# PRELIMINARY SITE PLANS

# 3420 ROCHESTER ROAD

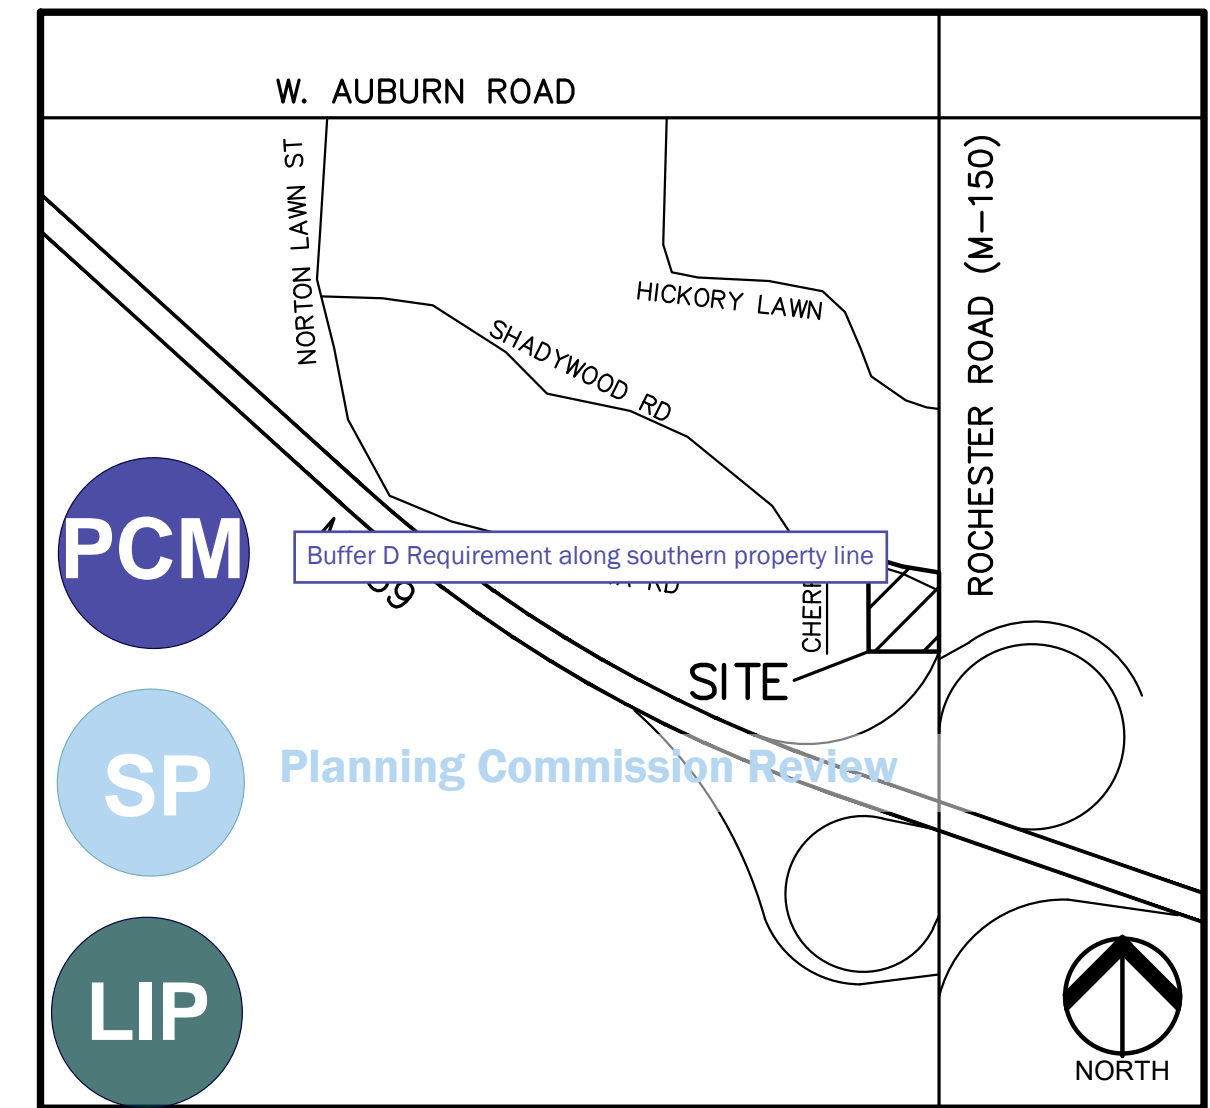
**Site Plan Review**

Reviewed for compliance with City Ordinance, Building and Fire Codes  
Conditions and mark-ups noted throughout plan set must be addressed prior to final approval
